# Access Compliance Report

## Public Rights-of-Way

### (Curb Ramps)

Intersection ID: 26775	Main Street: CREEK_BEND_DR	Cross Street: ELM_CREEK_LN	Location: SE
ADA ID: 07856A443D6E	Ramp Type: PerpDiag	Initial Pass/Fail: Fail	Overall Compliance: No
			Severity Score: 21.25

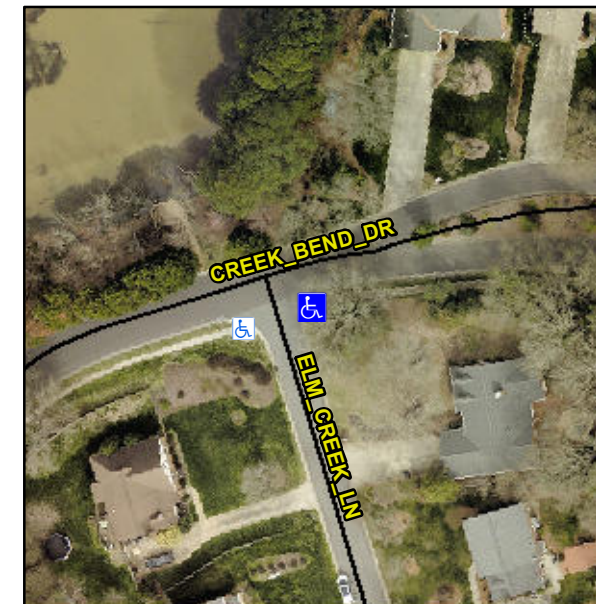
**Not Found, R304.5.1, R304.2.2**

Compliance	Description	Data	Compliance	Description	Data
N/A	Ramp Length (in)	26.0	No	Ramp Slope (%)	9.4
No	Ramp Width (in)	42.0	Yes	Ramp XSlope (%)	1.5
N/A	Flare Type LT	N/A	N/A	Flare Type RT	N/A
N/A	Flare Slope LT (%)	N/A	N/A	Flare Slope RT (%)	N/A
N/A	Flare Traversable LT?	N/A	N/A	Flare Traversable RT?	N/A
N/A	Landing Length (in)	N/A	N/A	DWS Provided?	N/A
N/A	Landing Width (in)	N/A	N/A	DWS Contrast?	N/A
N/A	Landing Slope (%)	N/A	N/A	DWS Length (in)	N/A
N/A	Landing X Slope (%)	N/A	N/A	DWS Full Width?	N/A
N/A	Landing Curb? (Y/N)	N/A	N/A	DWS Offset (in)	N/A
N/A	Shared Landing?	N/A			
N/A	Gutter Ponding?	N/A	N/A	Gutter Slope (%)	N/A
N/A	Gutter Lip Ht (in)	N/A	N/A	Gutter X Slope (%)	N/A
N/A	Painted X Walk1?	No	N/A	Painted X Walk2?	No
	X Walk 1 Direction	To N		X Walk 2 Direction	To W
N/A	X Walk 1 Width (in)	N/A	N/A	X Walk 2 Width (in)	N/A
	X Walk 1 Slope (%)	1.8		X Walk 2 Slope (%)	2.8
	X Walk 1 X Slope (%)	0.1		X Walk 2 X Slope (%)	2.2

**Remove & Replace Curb Ramp With Two New Directional Ramps or Equivalent.**
